## TROJAN NUCLEAR PLANT

PGE-1063, "Supplement to Applicant's Environmental Report, Revision 2"

**Supplement to Applicant's Environmental  
Report**

**Revision 2**

Figure 3.2-1 Decommissioning / Site Restoration Schedule

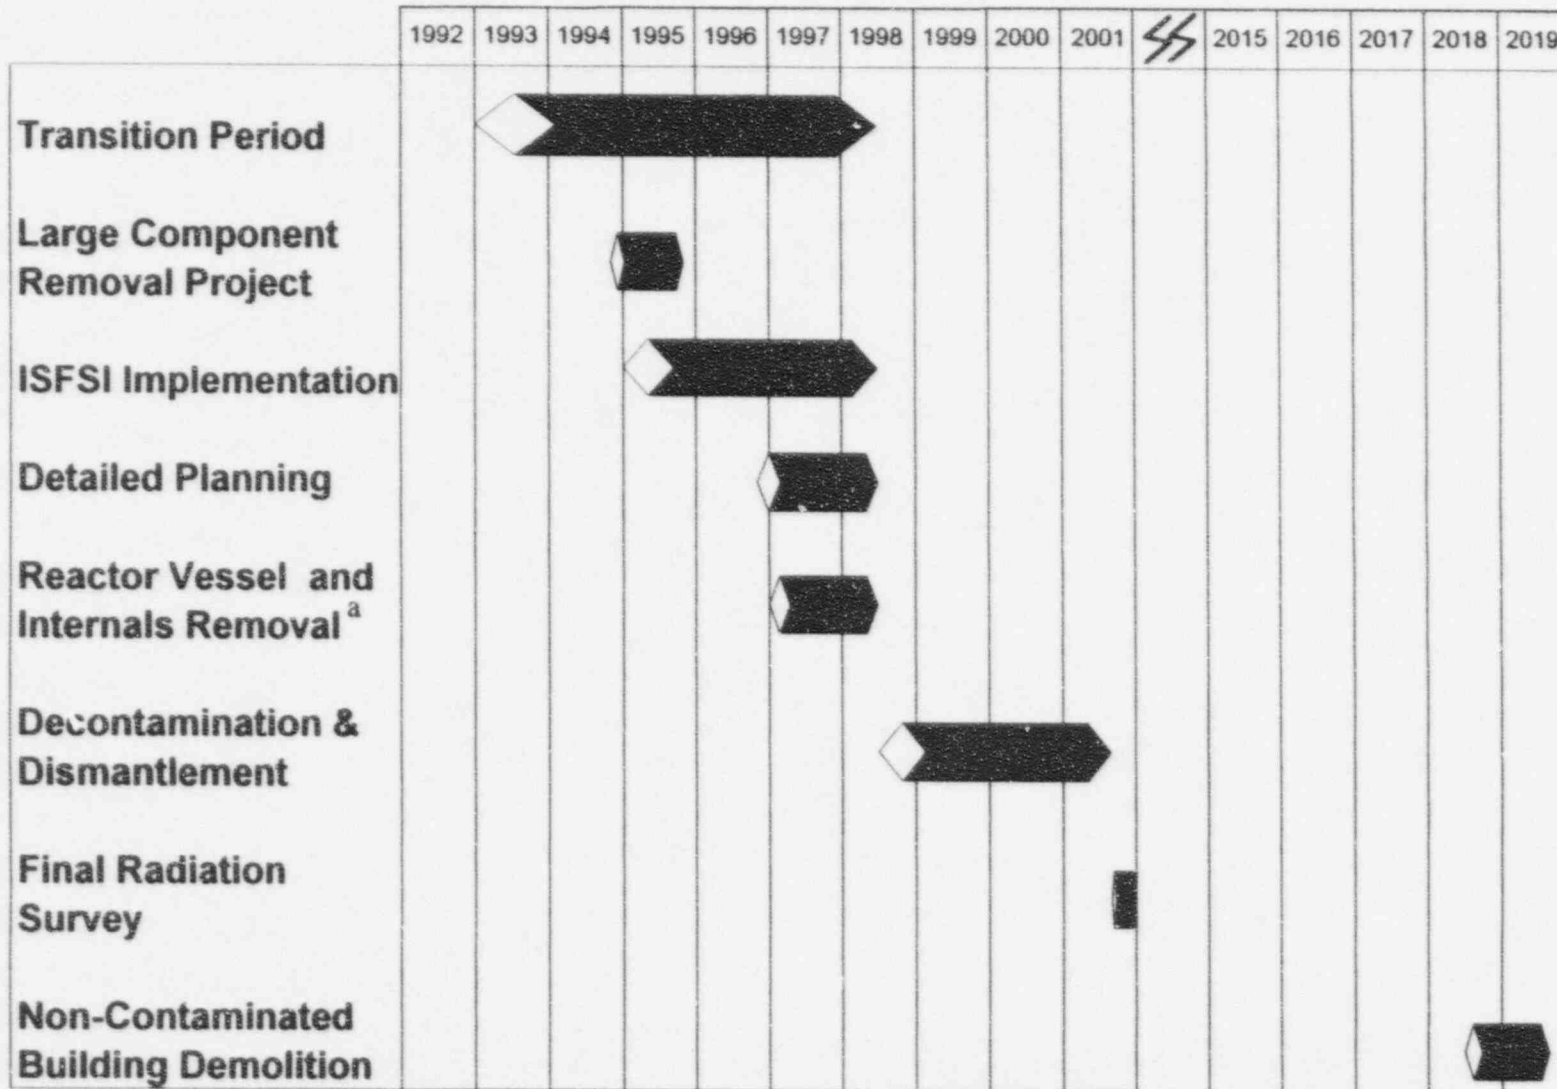
a This schedule reflects the option of intact removal of the reactor vessel and internals. If this project is canceled and the option of separate removal and segmentation of the reactor vessel internals is selected, then completion of the project is scheduled for late 1998 to early 2000.
